Tender Question & Answer Log

25009 – Merkburn Holdings

To: All Bidders
 Date: July 28, 2025
 Issue #: 02
 Project: **Merkburn Holdings Landlord Demising Walls**
 Project Address: 1050 Morrison Drive, 3rd Floor, Ottawa, Ontario
 ASDG Project #: **25009**
 Issued By: Sonja A. Schroeter, Principal & Lead Interior Designer

1
ID-2
PARTITION PLAN
SCALE: 1/8"=1'-0"

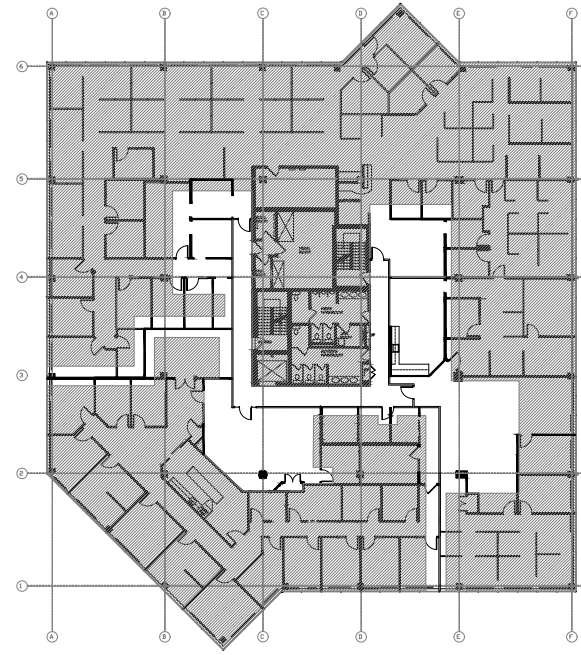
14.0	Demolition Plan	On Landlord demolition ID-1.1 we removing drywall on both sides and removing studs and insulation? What about kitchen cabinets and ceramic tile?	Refer to attached sketch SK-02 of ID-1.1 Demolition Plan for updated demolition scope and sketch SK-01 Partition Plan for updated partition scope.	2

1
ID-1.1
DEMOLITION PLAN
SCALE: 1/8"=1'-0"

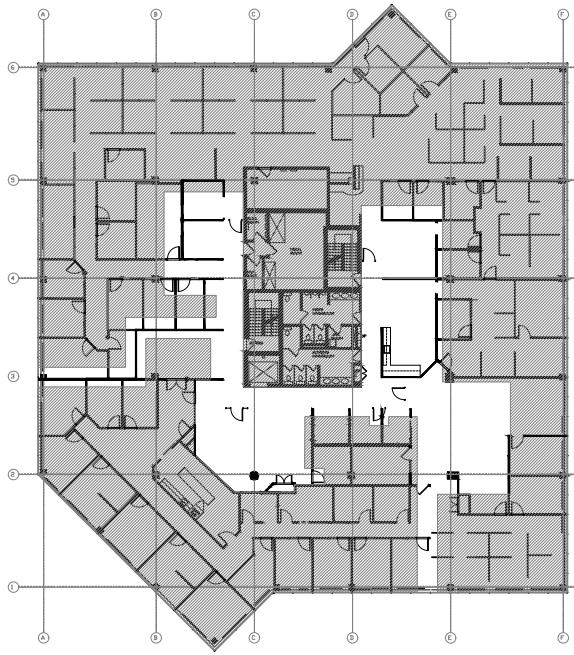
11.0	Demolition Plan	The demo plan notes to remove and relocate doors and frames but the door schedule calls for all new. Please confirm.	Contractor to remove and dispose doors and frames. All doors on the Door Schedule are to be new as noted.	2

15.0	Reflected Ceiling Demolition Plan	Drawing ID-1.2 shows walls requiring demo in N.I.C Hatch. The right side of drawing is cut off. How far back do we go?	Refer to response #14.0.	2

16.0	Demolition Plan	Demo will affect adjacent walls, and walls being demoed in N.I.C area will require painting. Please	Refer to response #14.0.	2
